NORTH ANNA POWER STATION

Chapter 4.0 Design Features

Improved Technical Specifications

**NORTH ANNA POWER STATION
IMPROVED TECHNICAL SPECIFICATION CONVERSION**

Figure 5.1.1
 Map Defining Unrestricted Areas for Radioactive Gaseous and Liquid Effluents
 2-17-94

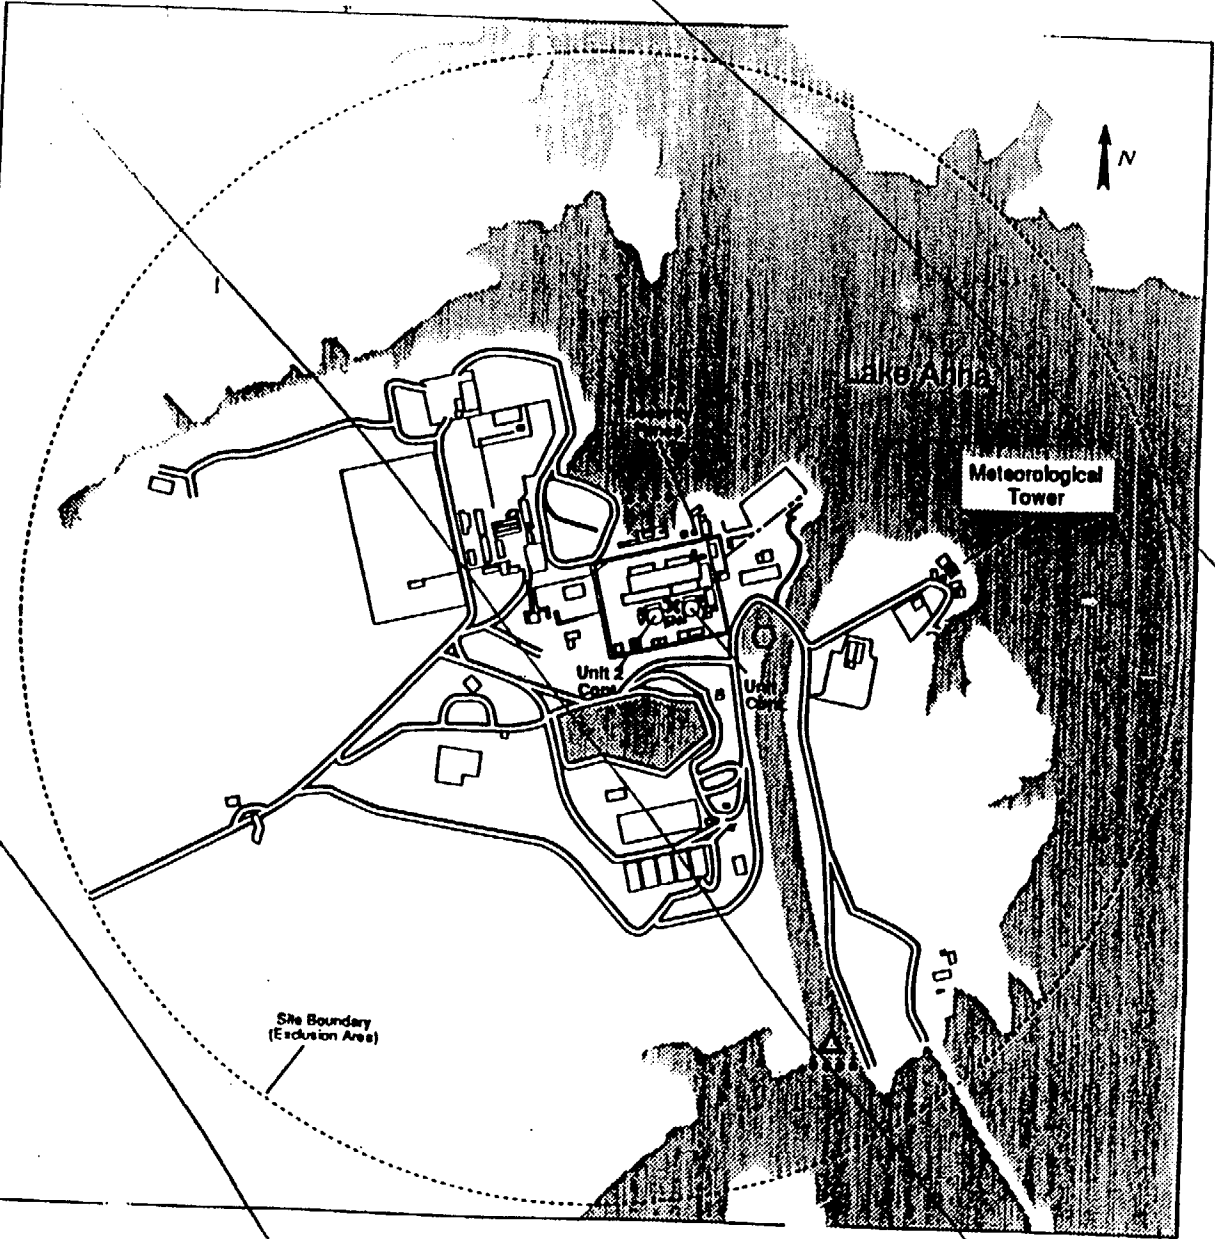
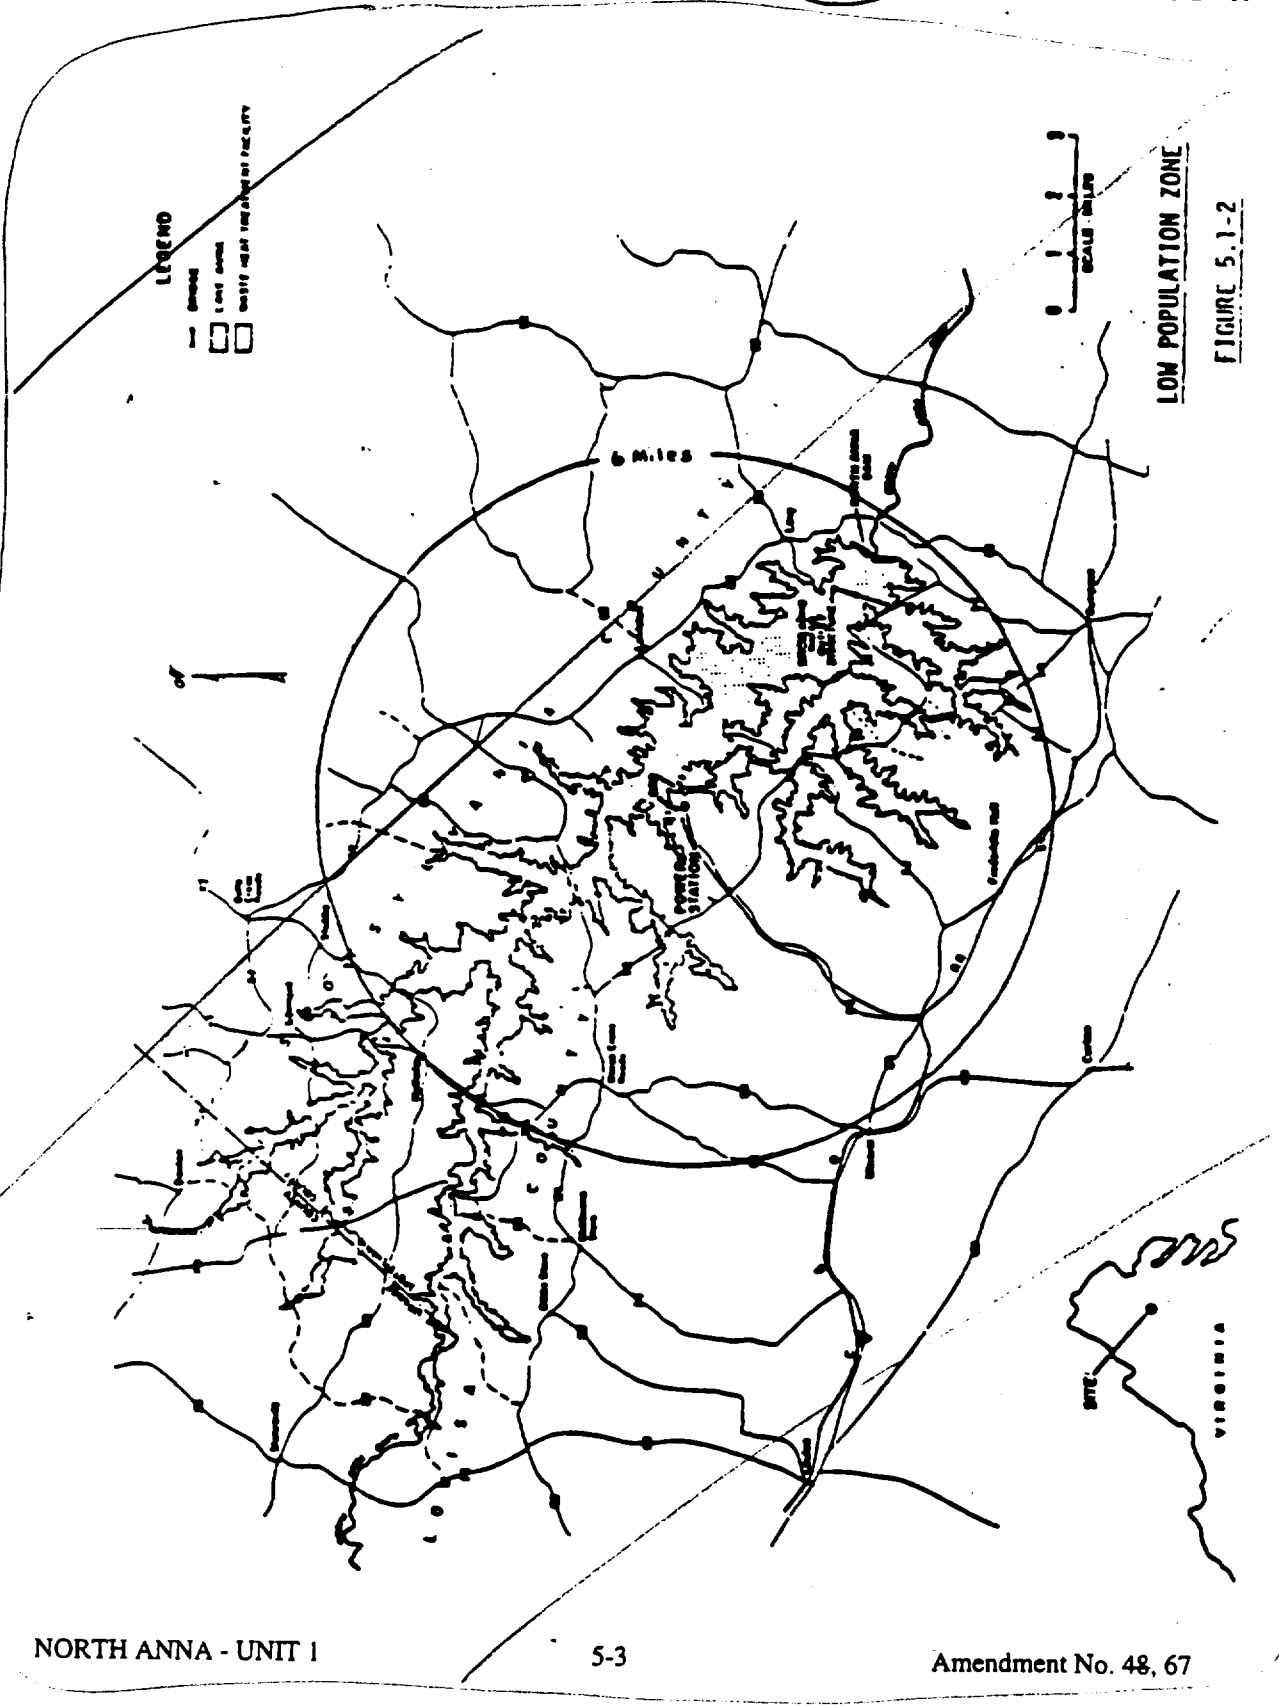
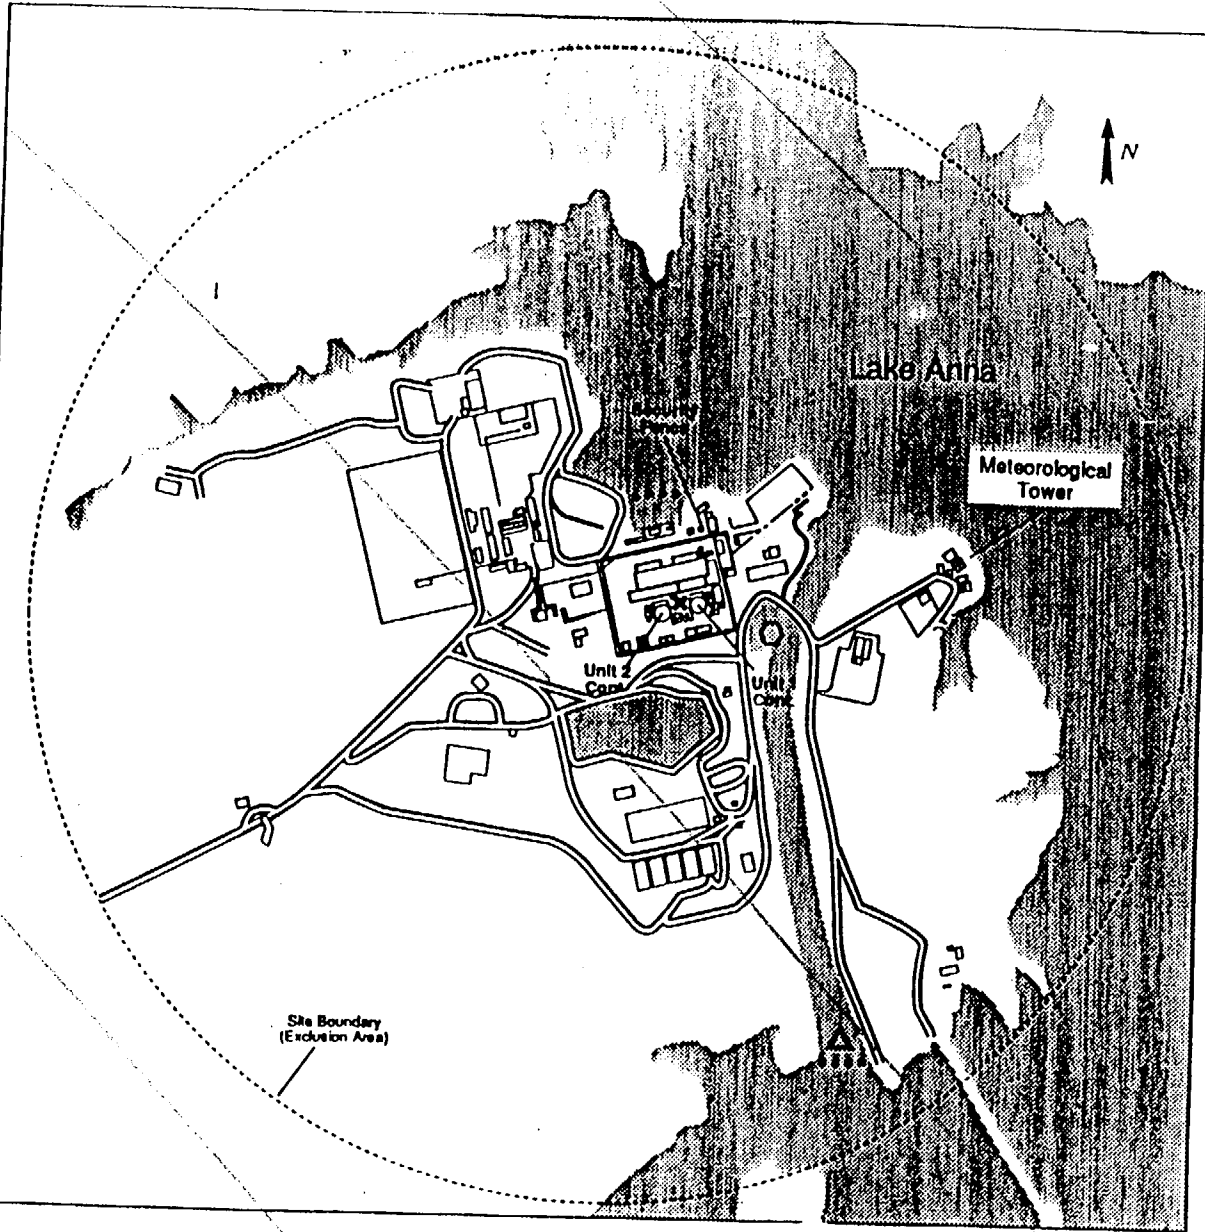
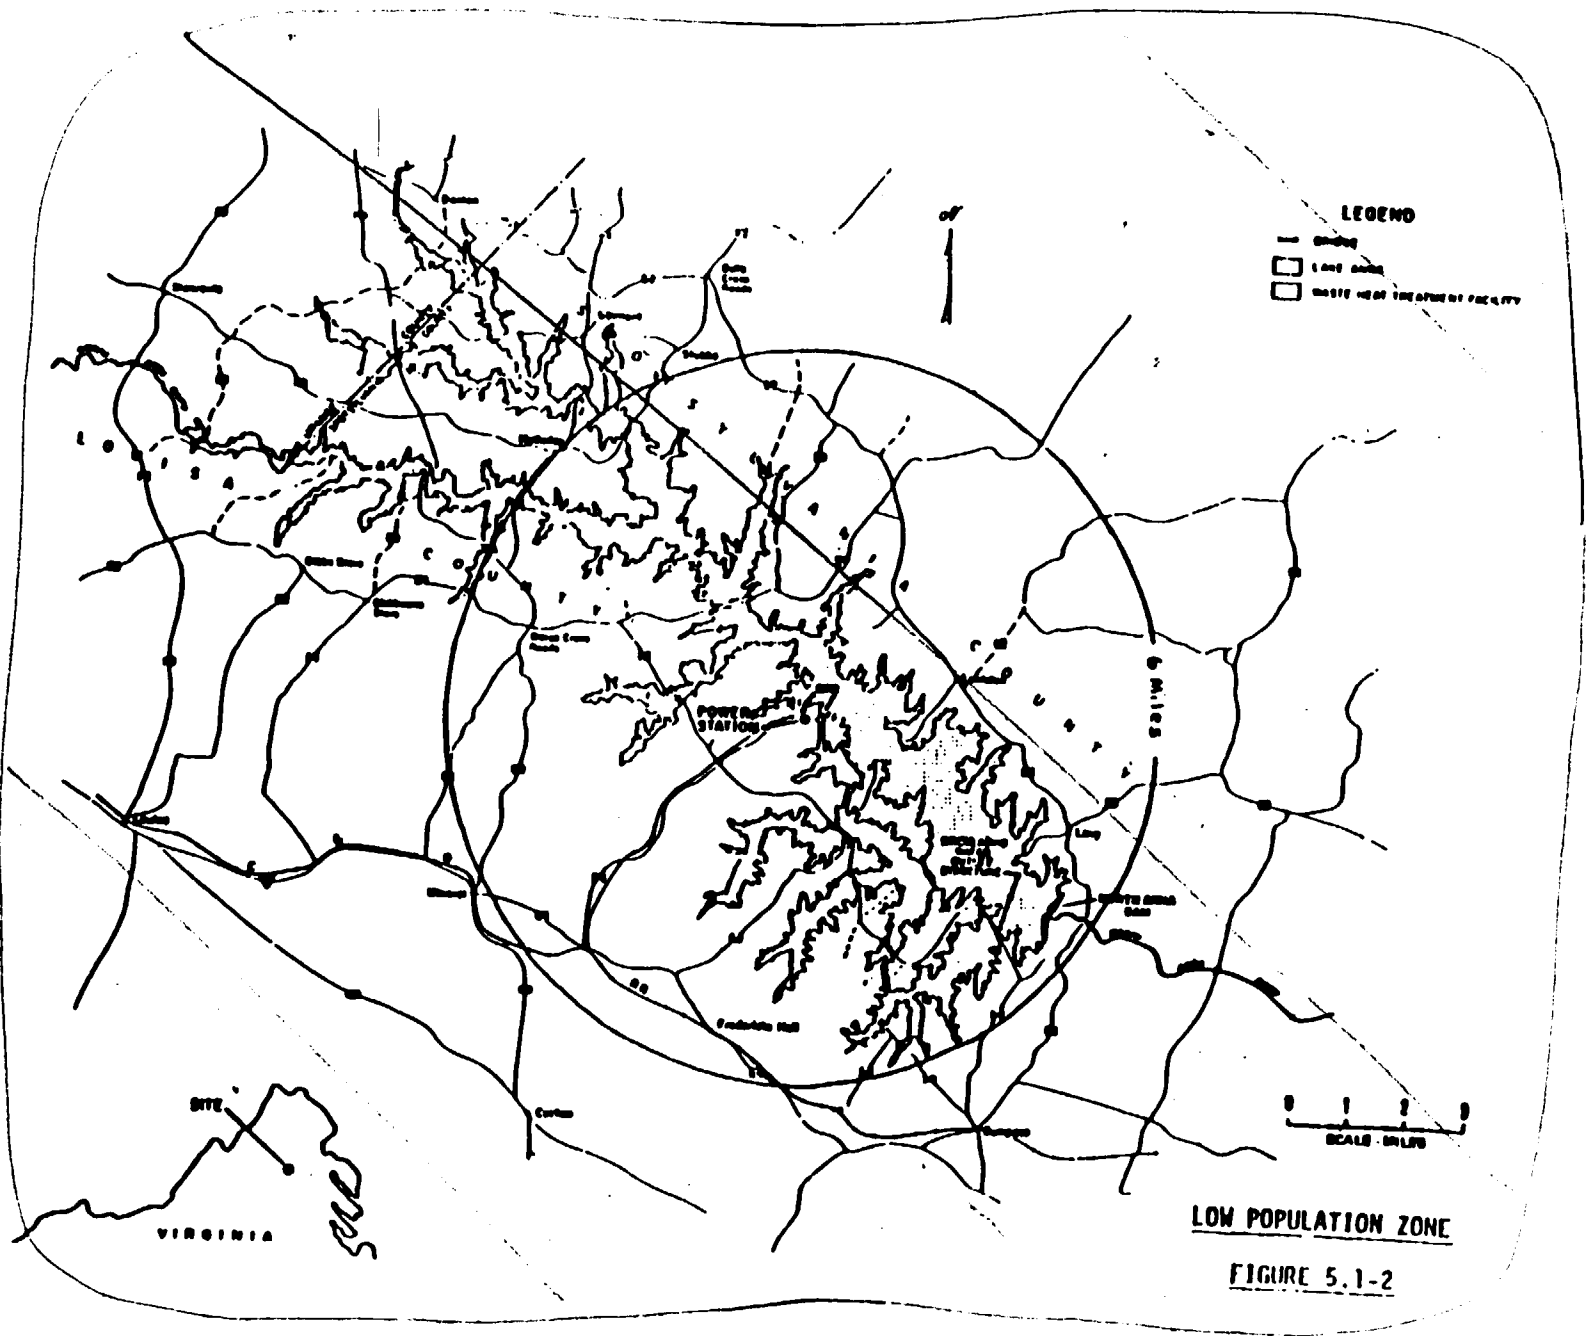
- LA.1 *(Type 1 – Removing Details of System Design and System Description, Including Design Limits)* CTS 5.1 contains information on the site exclusion area, the low population zone, and unrestricted areas for radioactive gaseous and liquid effluents. CTS 5.1 includes Figure 5.1.1, Map Defining Unrestricted Areas for Radioactive Gaseous and Liquid Effluents, and Figure 5.1.2, Low Population Zone. The ITS does not contain this information. This changes the CTS by removing this information.

The removal of these details, which are related to system design, from the Technical Specifications is acceptable because this type of information is not necessary to be included in the Technical Specifications to provide adequate protection of public health and safety. The ITS still retains site location information which satisfies the Design Features description of 10 CFR 50.36(c)(3). Also, this change is acceptable because the removed information will be adequately controlled in the UFSAR. The UFSAR is controlled under 10 CFR 50.59 which ensures changes are properly evaluated. This change is designated as a less restrictive removal of detail change because information relating to system design is being removed from the Technical Specifications.
